Access Compliance Report

Public Rights-of-Way

(Curb Ramps)

Intersection ID: 51072	Main Street: KEMPSFORD_DR	Cross Street: GRICKLADE_DR	Location: SW
ADA ID: D799597A40EC	Ramp Type: PerpDiag	Initial Pass/Fail: Fail	Overall Compliance: No
Severity Score: 35			
Codes/Mitigation Info/Possible Solution		Field Measurements/Component Compliance

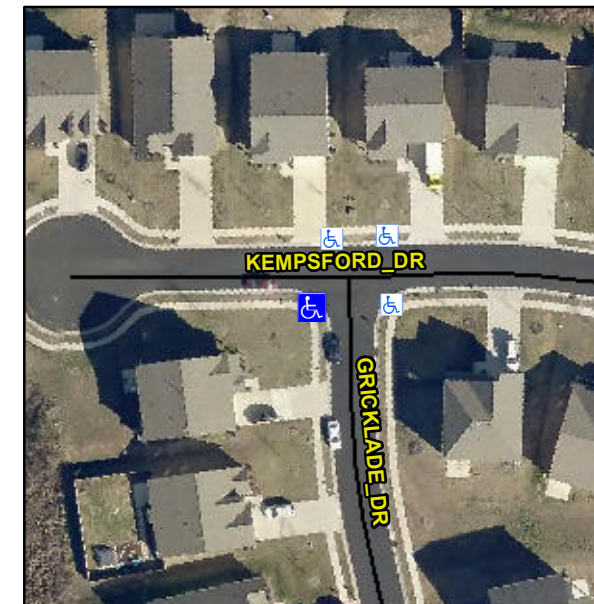
Not Found, R304.5.1, R304.2.2, R304.5.3

Compliance	Description	Data	Compliance	Description	Data
N/A	Ramp Length (in)	49.0	No	Ramp Slope (%)	12.6
No	Ramp Width (in)	47.0	No	Ramp XSlope (%)	3.2
N/A	Flare Type LT	N/A	N/A	Flare Type RT	N/A
N/A	Flare Slope LT (%)	N/A	N/A	Flare Slope RT (%)	N/A
N/A	Flare Traversable LT?	N/A	N/A	Flare Traversable RT?	N/A
N/A	Landing Length (in)	N/A	N/A	DWS Provided?	N/A
N/A	Landing Width (in)	N/A	N/A	DWS Contrast?	N/A
N/A	Landing Slope (%)	N/A	N/A	DWS Length (in)	N/A
N/A	Landing X Slope (%)	N/A	N/A	DWS Full Width?	N/A
N/A	Landing Curb? (Y/N)	N/A	N/A	DWS Offset (in)	N/A
N/A	Shared Landing?	N/A			
N/A	Gutter Ponding?	N/A	N/A	Gutter Slope (%)	N/A
N/A	Gutter Lip Ht (in)	0.5	N/A	Gutter X Slope (%)	N/A
N/A	Painted X Walk1?	No	N/A	Painted X Walk2?	No
	X Walk 1 Direction	To E		X Walk 2 Direction	To N
N/A	X Walk 1 Width (in)	N/A	N/A	X Walk 2 Width (in)	N/A
	X Walk 1 Slope (%)	2.4		X Walk 2 Slope (%)	1.4
	X Walk 1 X Slope (%)	0.5		X Walk 2 X Slope (%)	0.7

Remove & Replace Curb Ramp With Two New Directional Ramps or Equivalent.
